SERVICE BULLETIN

Service Bulletin No.: DA20-75-01 Rev 0

Title: Rotax Airbox Installation DA20-A1/100

Figure 1
Carburetor Heat Cable Installation

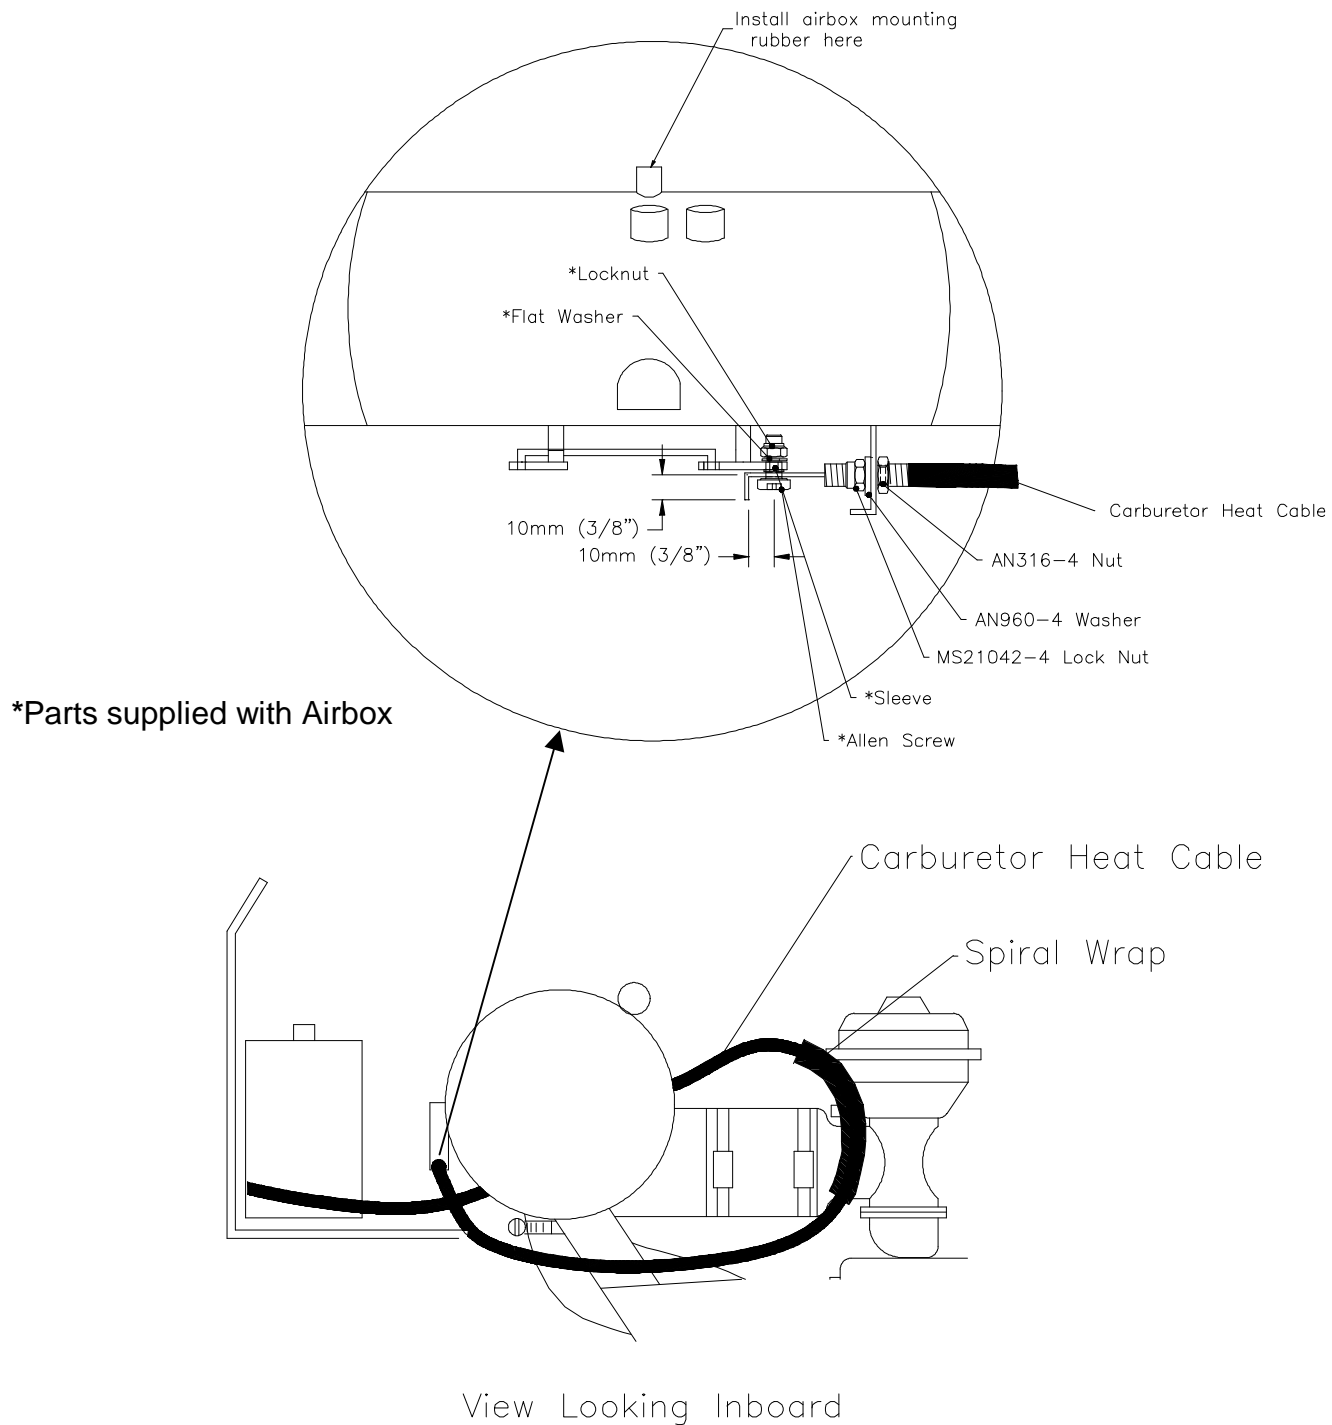
- 10.17 Route and connect the carburetor heat cable as shown in figure 1. Secure the cable as necessary with tie-wraps. Spiral wrap may be necessary where cable passes the right hand carburetor. Reference figure 1.

Figure 2
Vent Tubing Modification/Installation

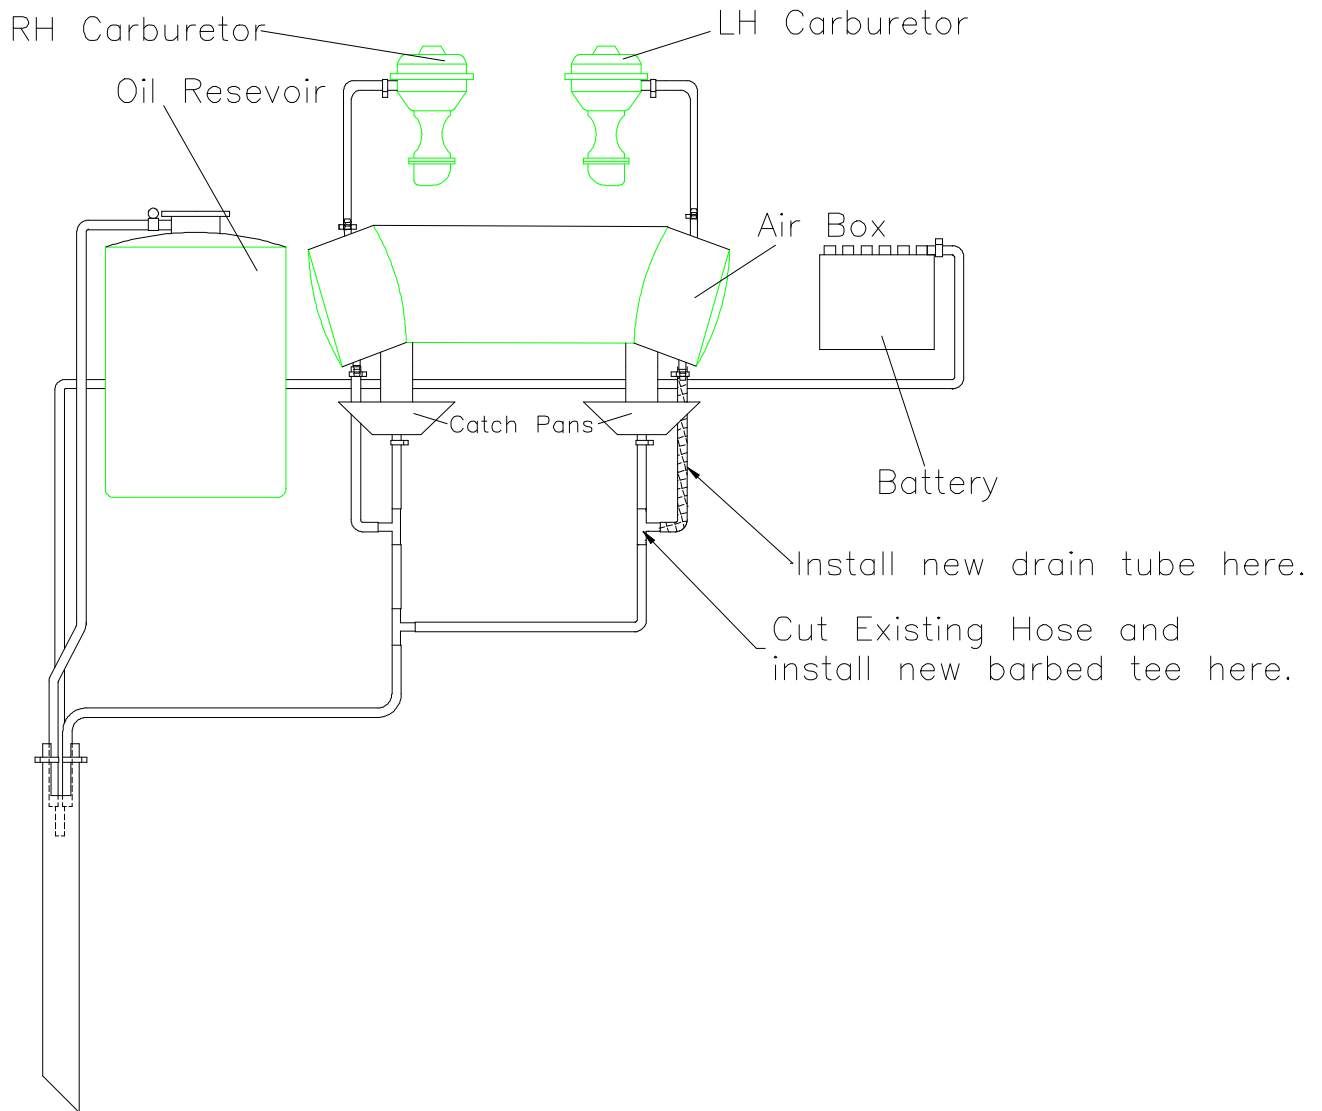
- 10.18 Connect left hand airbox drain tube by cutting existing left hand catch pan drain and installing supplied barbed tee fitting as shown in figure 2.
